P5026A-03-S

Safety Service Note

P5026A Keysight Streamline USB Vector Network Analyzer

“POTENTIAL BURN INJURY (HIGH TEMPERATURE) HAZARD”

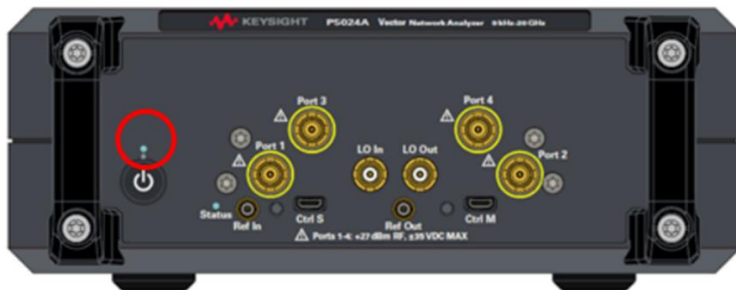
Symptom:

VNA fails to start with the following symptoms.

1. LED indicator (below circle) turns red.
2. cooling fan does not work
3. If user leaves the VNA with this LED indicator red without turning off power switch, it continues to overheat and becomes too hot.

Solution-1: Update VNA firmware by user

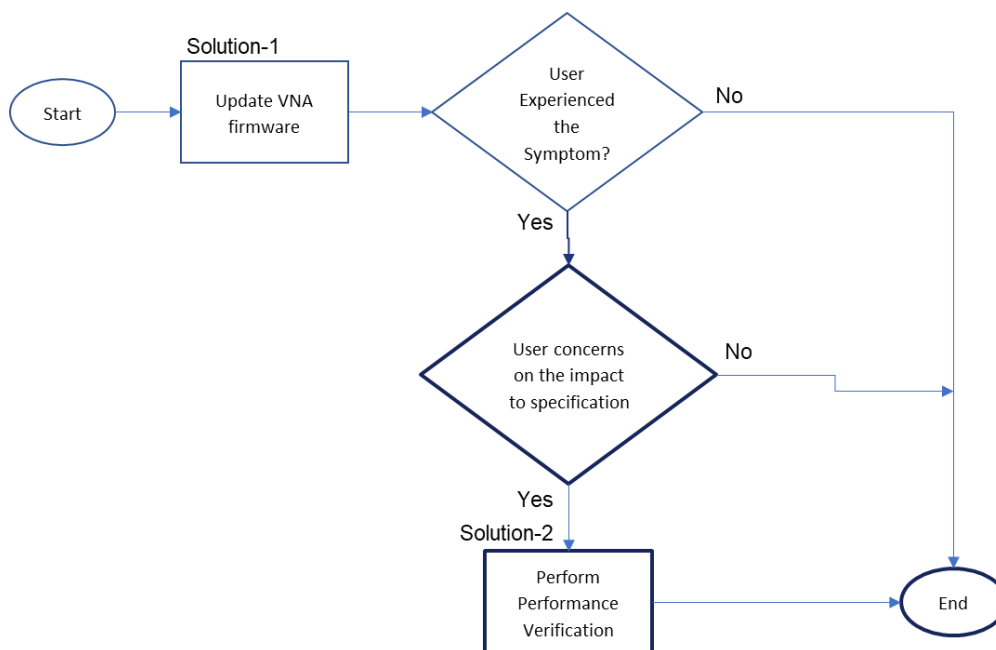
Action-1: Updating the firmware eliminates this potential risk of overheating.

1. **Install the latest VNA firmware Rev. A.15.40.13 or newer on users' controller PC(s).**
The latest firmware enhanced the thermal fan control mechanism.
2. Once the latest firmware is installed, proceed with the restart of both **controller PC** and **VNA**.
3. Launch the VNA firmware. Ensure VNA powers up and launches into firmware correctly after firmware update is done.
